Amendments to ECE/TRANS/WP.29/GRE/2014/7

I. Proposal

(Insert the following missing diagram showing the visibility of angles)

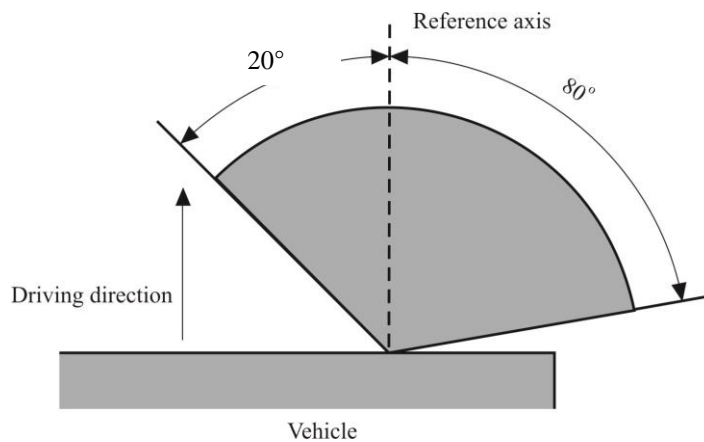
Annex 1, paragraph 1., at the end of the proposed text insert the missing diagram:

“1. Front position lamps

$$V = +15^\circ / -10^\circ$$

However, in the case where a device is intended to be installed with its H plane at a mounting height less than 750 mm above the ground, the angle of 10° below the horizontal may be reduced to 5° .

Front position lamps (for a pair of lamps)

$$V = + 15^\circ / - 10^\circ$$

However, in the case where a device is intended to be installed with its H plane at a mounting height less than 750 mm above the ground, the angle of 10° below the horizontal may be reduced to 5° . “

"Annex 3

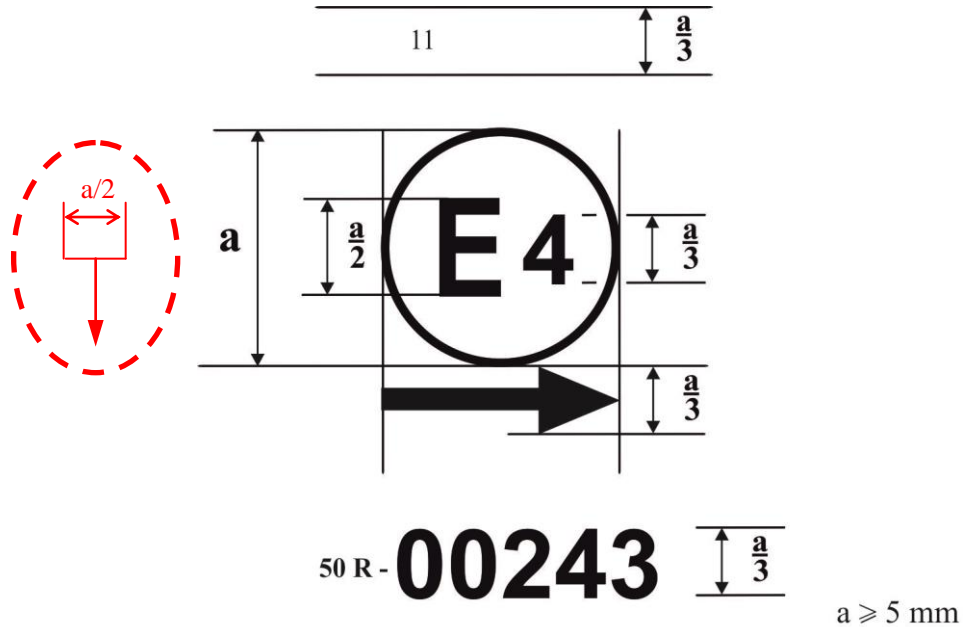
Annex 3, correctly highlight the marking clause for the interdependent lamps:

Interdependent lamps

Marking of an interdependent lamp comprising part of an interdependent lamp system providing:

A rear direction indicator lamp (category 12) approved in accordance with the requirements of Regulation No. 50,

A rear position lamp (MRY) approved as an interdependent lamp forming part of an interdependent lamp system in accordance with the requirements of Regulation No. 50,

A stop-lamp (MSY) approved as an interdependent lamp forming part of an interdependent lamp system in accordance with the requirements of Regulation No. 50
